## **KESCO SUBDIVISION, REVISED**

APPLICATION NUMBER 2 DATE March 21, 2019

# DETAIL SITE PLAN

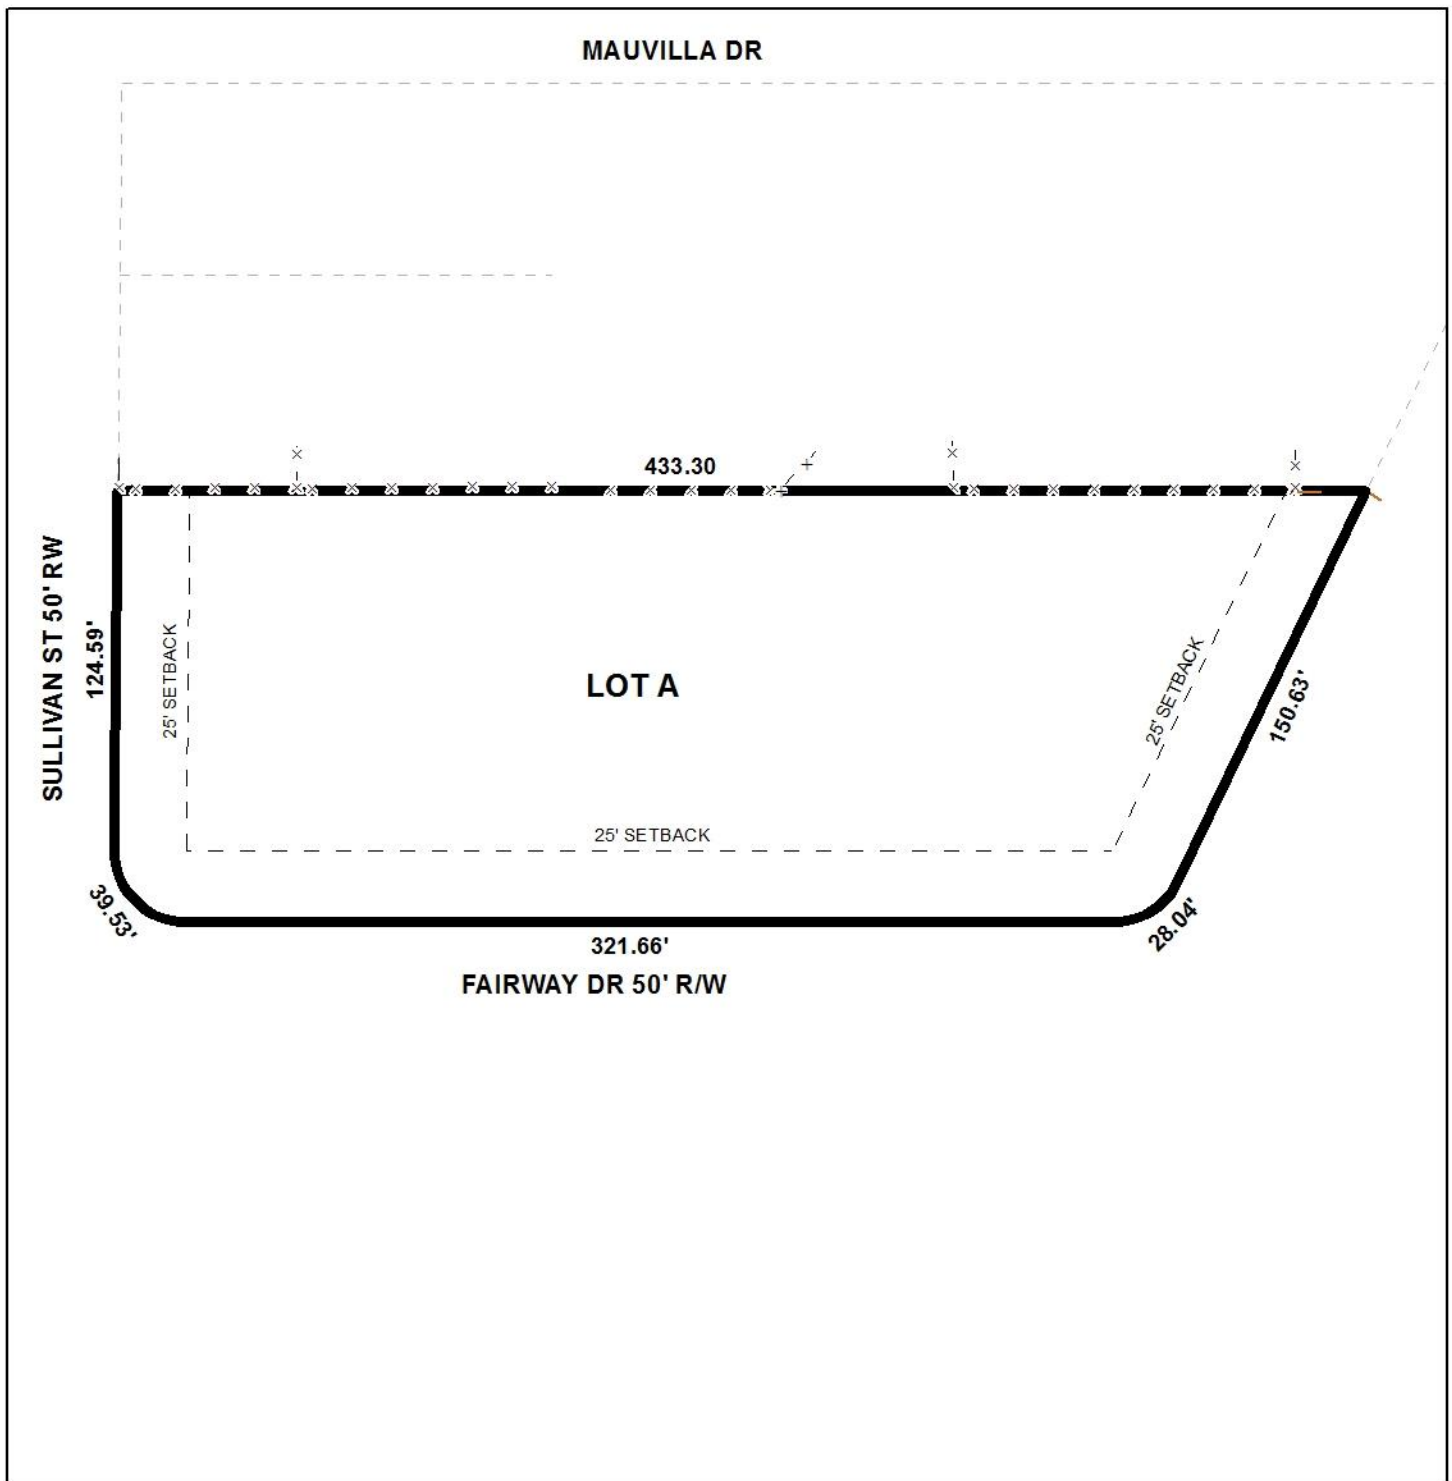
At the May 3, 2018 meeting, the Commission granted Tentative Approval to the site, subject to several conditions. While the plat has since been recorded reflecting compliance with the May 2018 conditions, the applicant now wishes to alter the following conditions; 1) the limitation of one curb cut to Fairway Drive, and 2) denial of direct access to the Government Boulevard Service Road. The applicant now proposes one curb cut to the Government Boulevard Service Road and two curb cuts to Sullivan Avenue.

The plan has been revised, and the retail and office space enlarged to 11,500 square feet (all other areas and spaces are the same). With the revised plan, access to the Government Boulevard Service Road is proposed as a one-way drive into the site, with the one-way circulation exiting to Fairway Drive. A second, two-way drive to Fairway is also proposed, as well as the proposed drive to Sullivan Avenue.

As indicated in the Traffic Engineering comments, with ALDOT and Traffic Engineering approval, and conformance to AASHTO standards, the allowance of the additional curb cuts may be appropriate.

The revised preliminary plat does illustrate the proper corner radius at both Fairway Drive and Sullivan Avenue, and Government Boulevard and Fairway Drive, as required by Section V.D.6. of the Subdivision Regulations, and should be retained on the Final Plat, if approved.

The revised preliminary plat does illustrate the 25' minimum building setback along all frontages and should be retained on the Final Plat, if approved.

- 1) retention of the dedicated corner radius at Fairway Drive and Sullivan Avenue per Section V.D.6. of the Subdivision Regulations;
- 2) retention of the dedicated corner radius at Government Boulevard and Fairway Drive per Section V.D.6. of the Subdivision Regulations;

- 3) retention of the lot size in square feet and acres;
- 4) retention of the 25' minimum building setback line along all frontages;
- 5) compliance with Engineering comments *FINAL PLAT COMMENTS (should be addressed prior to submitting the FINAL PLAT for review and/or signature by the City Engineer): A. Provide all of the required information on the SUBDIVISION PLAT (i.e. signature blocks, signatures, certification statements, written legal description, required notes, legend, scale, bearings and distances) that is required by the current Alabama State Board of Licensure for Professional Engineers and Land Surveyors. B. Provide a copy of the FINAL SUBDIVISION PLAT to the Engineering Dept. for review. No signatures are required on this drawing. C. After addressing all of the FINAL SUBDIVISION PLAT review comments by the Engineering Dept. provide the red-line markup, the ORIGINAL (with all other signatures) and one (1) copy of the revised*

- 6) placement of a note on the final plat requiring full compliance with Traffic Engineering comments (*Government Boulevard (US Highway 90) and its Service Road are ALDOT maintained roadways. Lot is limited to one curb cut each to Government Boulevard Service Road and Sullivan Avenue and two curb cuts to Fairway Drive with size, location and design to be approved by ALDOT (where applicable) and Traffic Engineering and conform to AASHTO standards. Any new on-site parking, including ADA handicap spaces, shall meet the minimum standards as defined in Section 64-6 of the City's Zoning Ordinance.*);
